Lowden Manor House, Chippenham

Heritage Statement Addendum

Submission Document – Listed Building Application

July 2026

3 Ground Floor Plan as Proposed

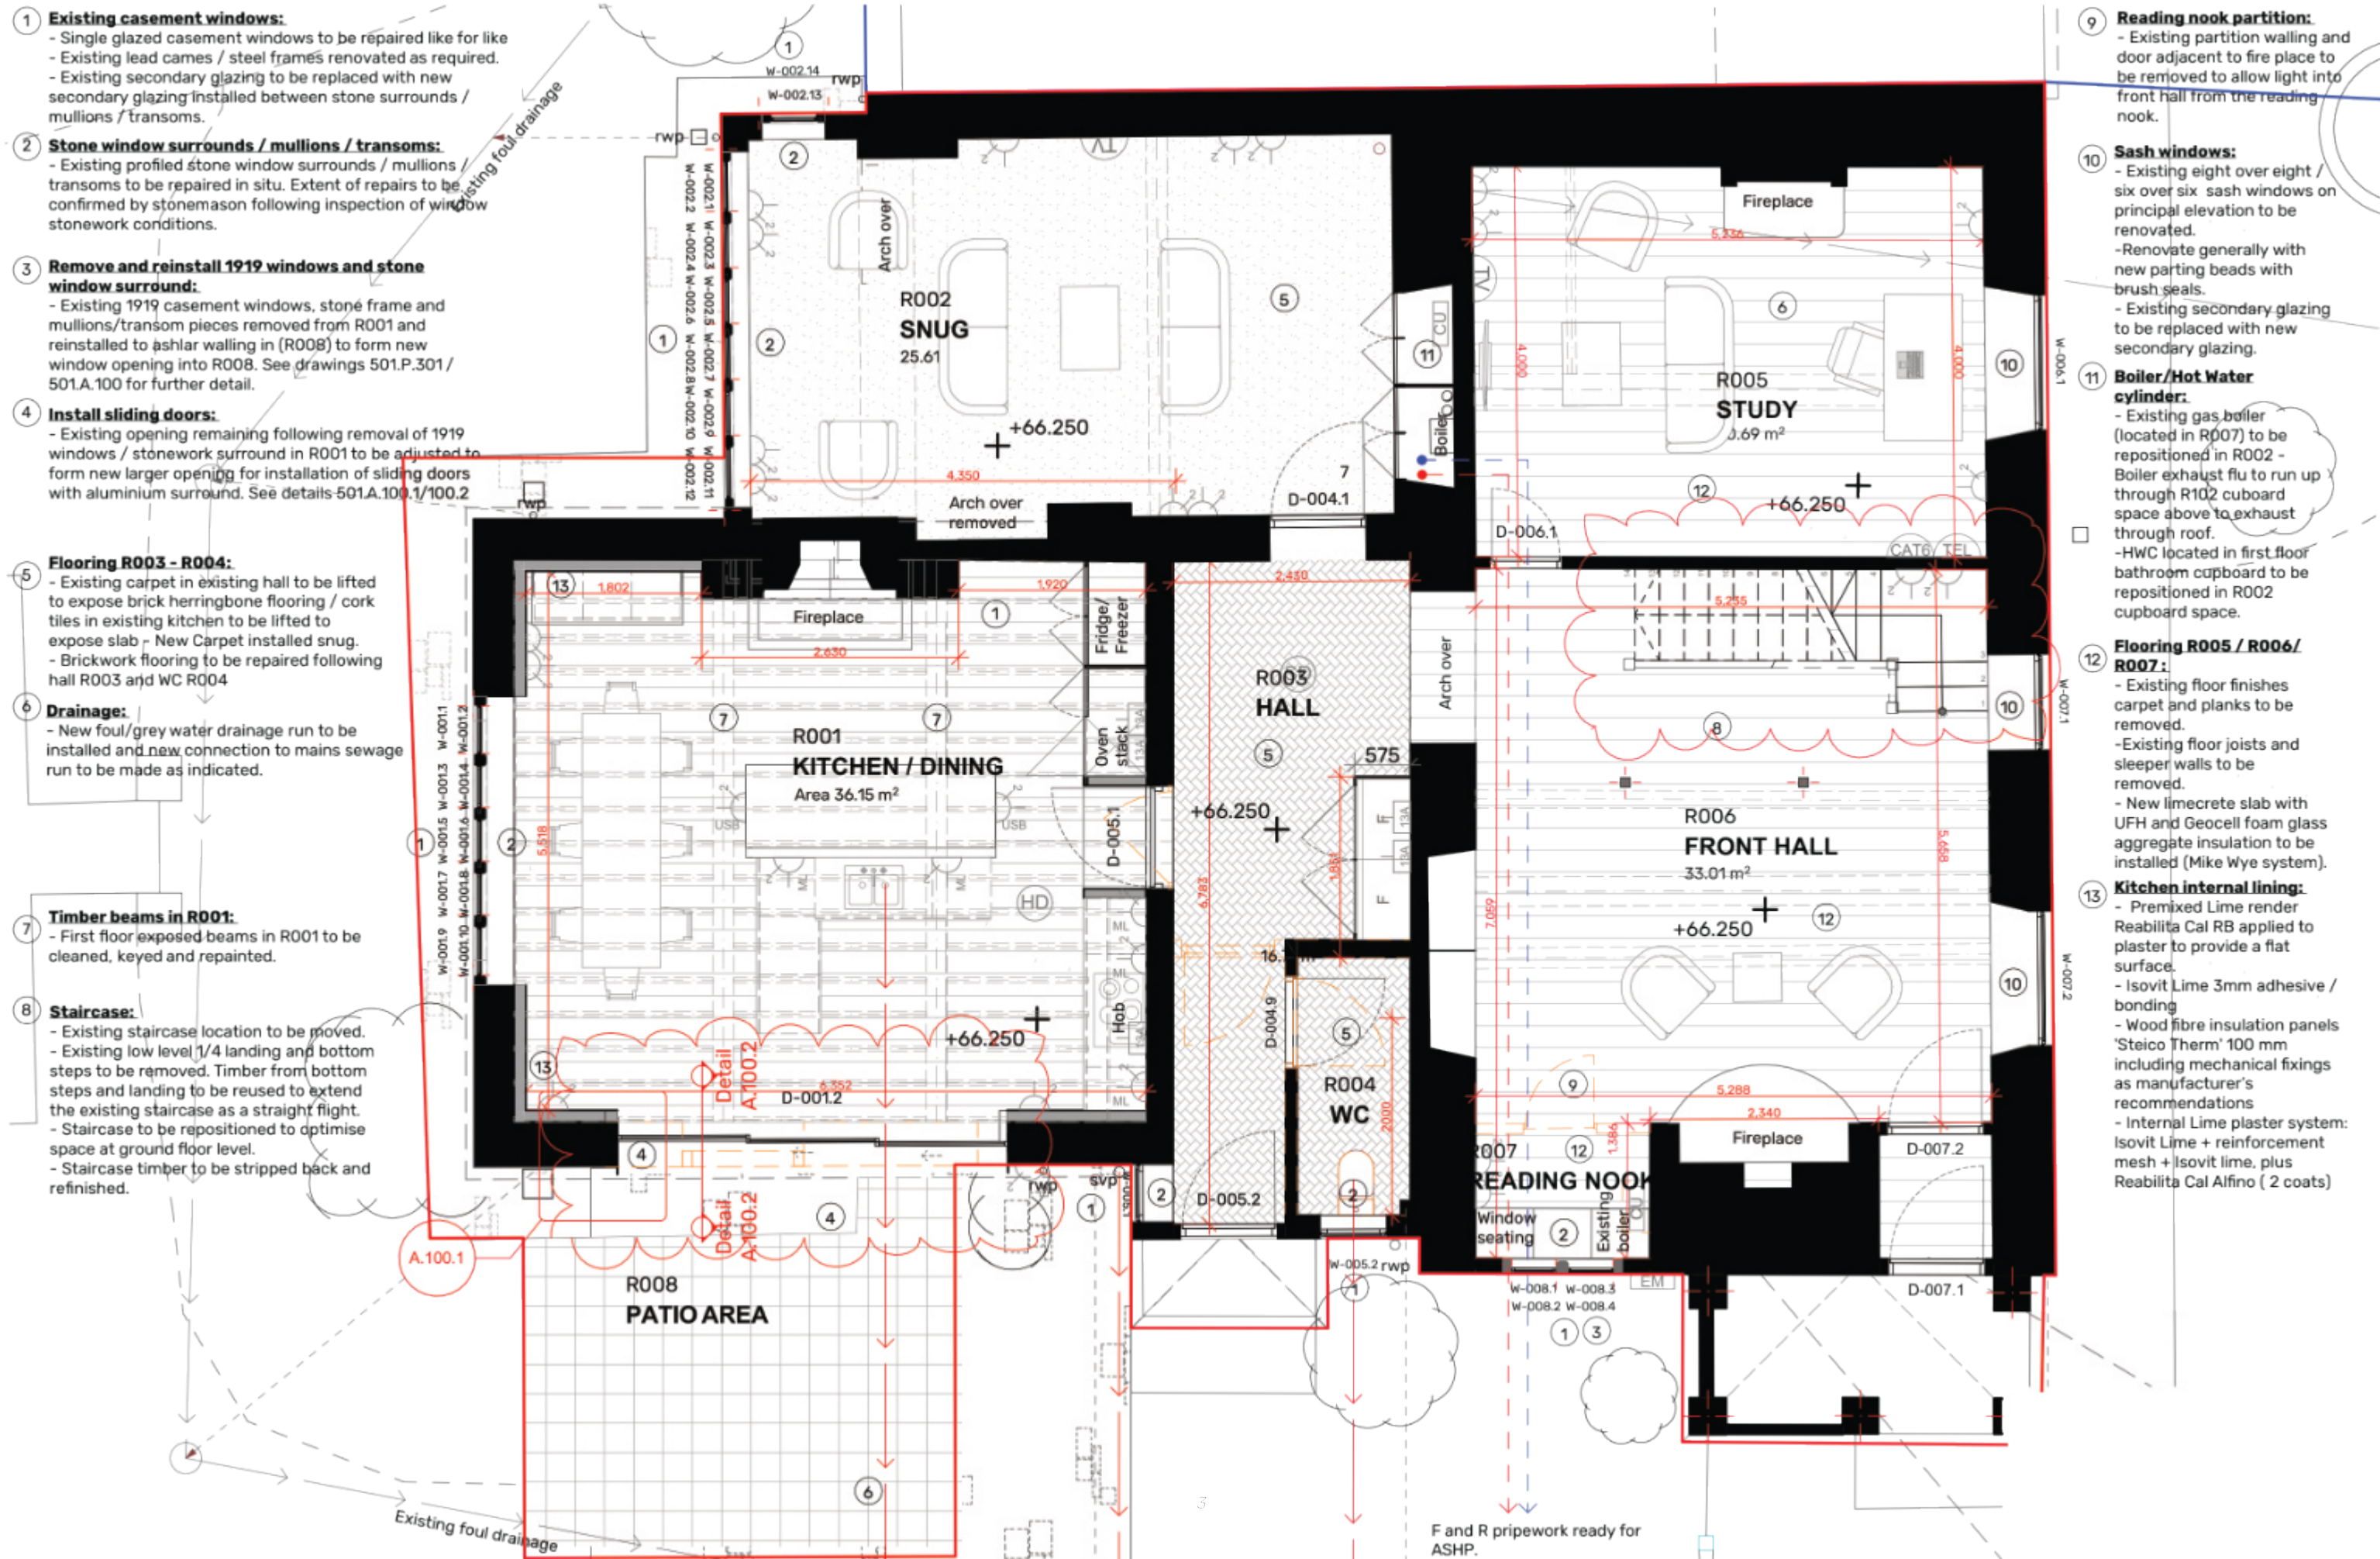
- Re-position primary staircase in front hall. Previous permission allowed for existing staircase to be mirrored 180 degrees. The new proposal retains the original orientation but moves the whole flight approximately 1m West, so that it sits against the existing wall to the Study, with the stair void increased.

- Install casement doors in East wall of Kitchen / Dining. Previous permission allowed for the installation of sliding doors with aluminium surrounds. The new proposal substitutes the sliding doors for steel casement doors and looks to reuse existing stone quoins and hood moulds for the new surround.

4 First Floor Plan as Proposed

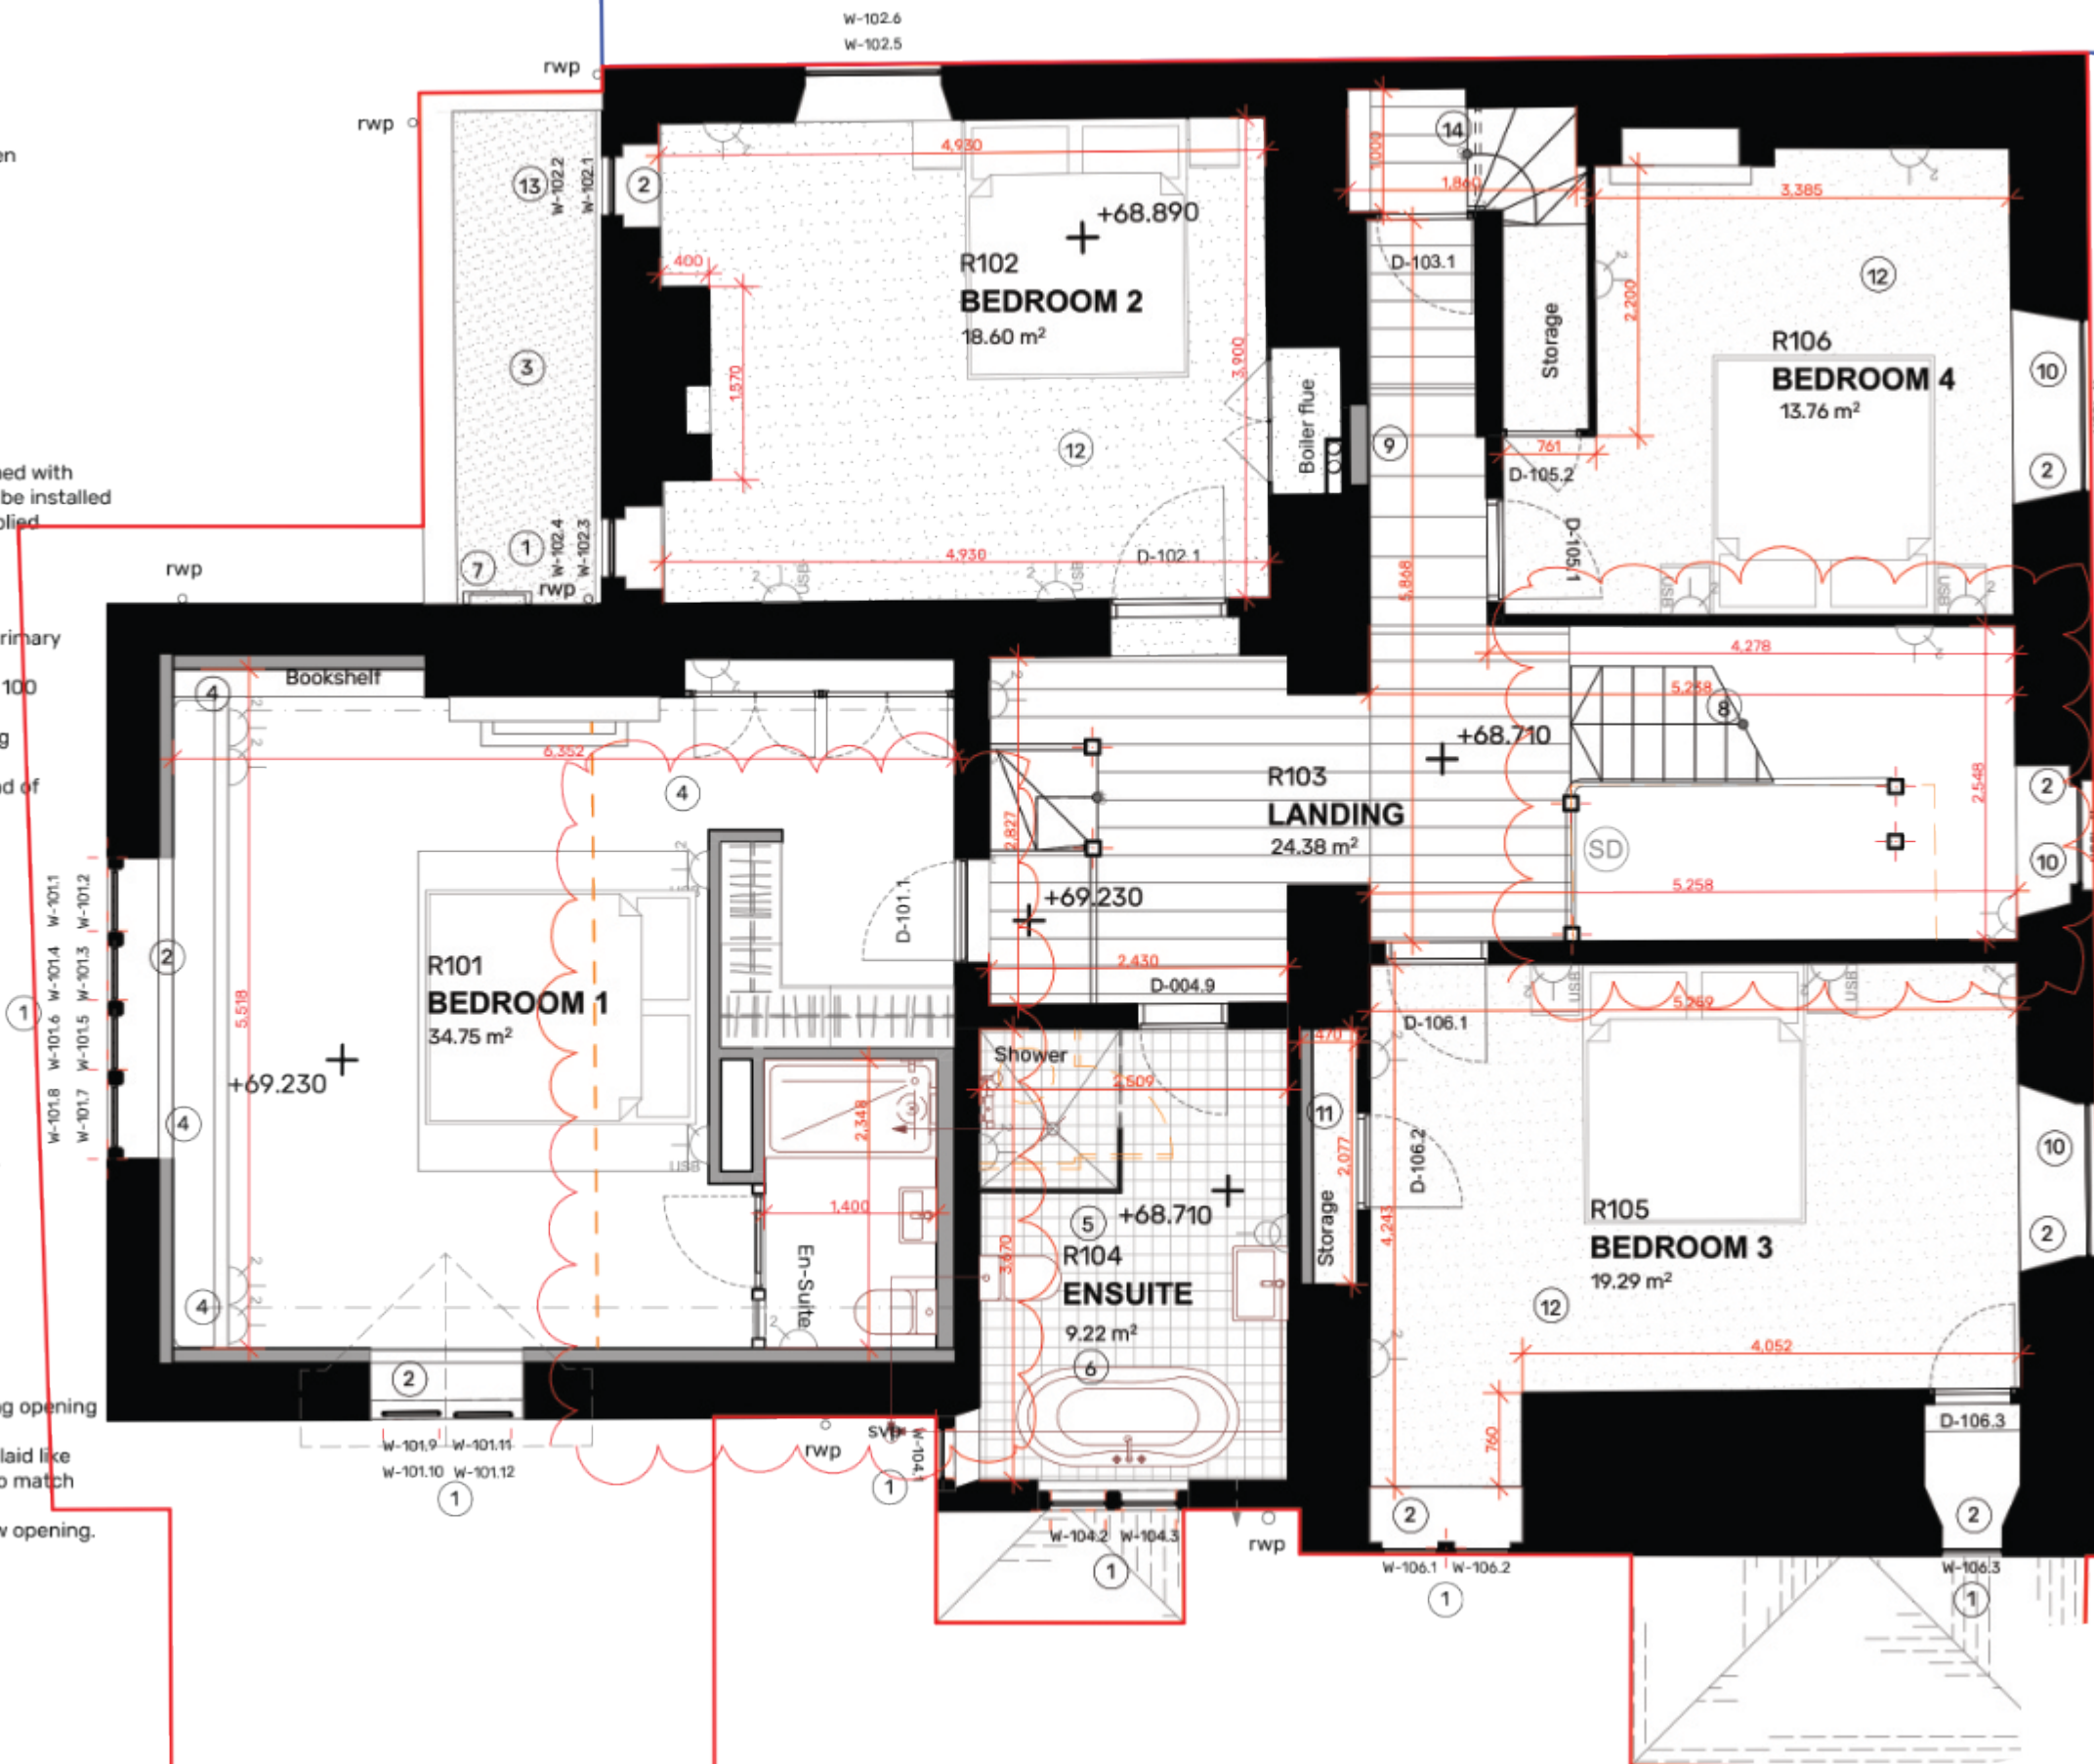
- Removal of existing partition wall between Landing/Playroom (R204) and Bedroom 5 (R205). This opens up the space to become more usable and suitable for modern family living.

- Internal alterations to Bedroom 1 . This includes a new en-suite bathroom, the removal of the existing ceiling south of the truss in Bedroom 1 to open up the space into the current attic and new partition walls including one next to the truss in the attic space.

4 Bedroom 1 R101 Alterations:

- Low level storage with bench installed by primary window.
- Wood fibre insulation panels 'Steico Therm' 100 mm internal lining
- New en-suite bathroom built within existing bedroom limit.
- Ceiling removed to expose roof to South end of bedroom
- Partition wall to provide storage spaces

8 Staircase opening in landing:

- Existing landing opening to be adjusted to accommodate adjusted flight of stairs. (Existing opening denoted with orange dashed line).
- Timber plank floor finish on landing to be relaid like for like and any new timber planks required to match existing size and finish.
- Balustrade/Stair posts adjusted around new opening.
